DOCKET NUMBER
PROD. & UTIL. FAC. 50-348/364 CIVP
WINSTON & STRAWN

April 29, 1992

In preparing for the upcoming hearing, one oversight in the Surrebuttal Testimony of Alabama Power Company has come to our attention. Rather than awaiting introduction of the testimony, we are calling this to the attention of the Board and parties at this time to avoid any confusion.

Figure 1

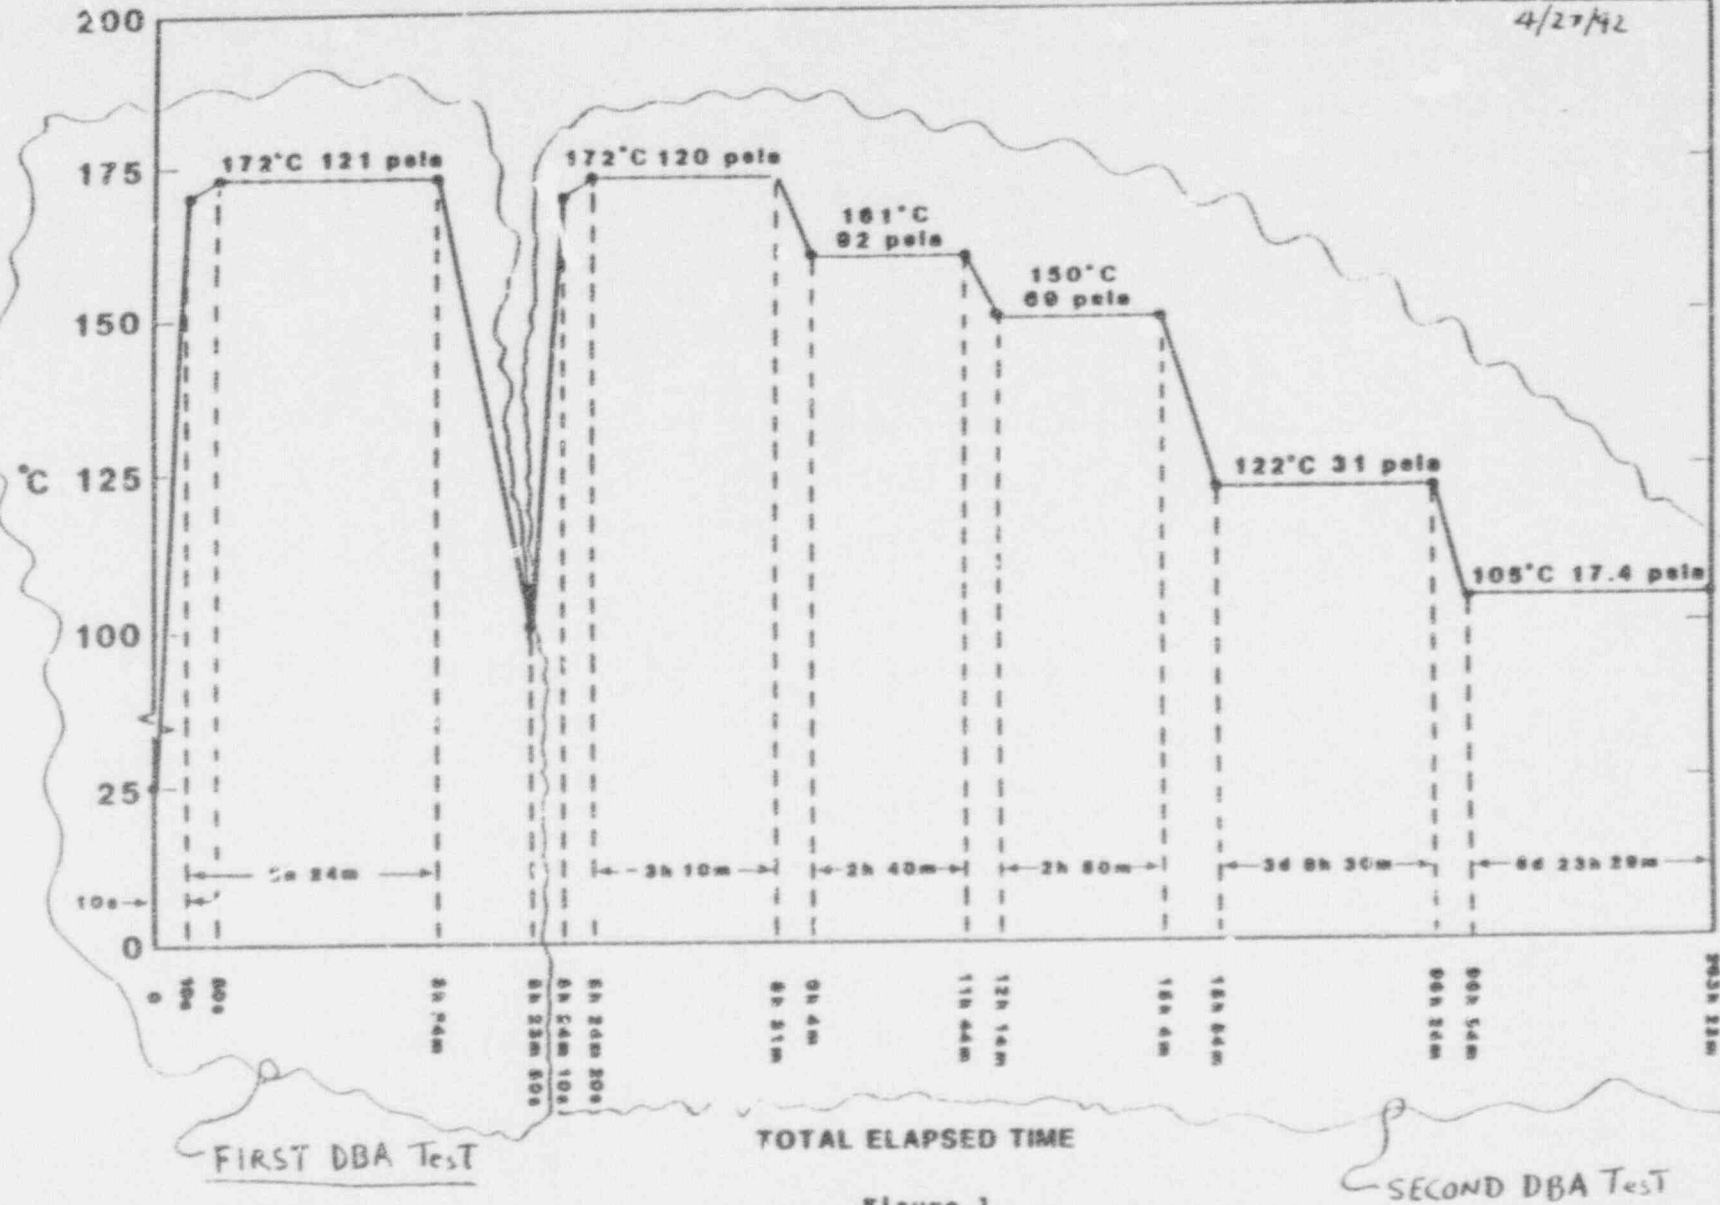
Specifically, in the testimony of Mr. Love on Terminal Blocks (Volume II of the Surrebuttal Testimony), at page 146, Mr. Love states that he has marked Figures 1 and 2 (the figures appear on pages 147 and 148, respectively) "to indicate each simulated DBA on the profiles." However, the Figures as they appear in the bound volume were not so marked. Attached are copies of the figures as they should have appeared, marked by Mr. Love.

MARKED BY: Jesse E. Love
4/27/92
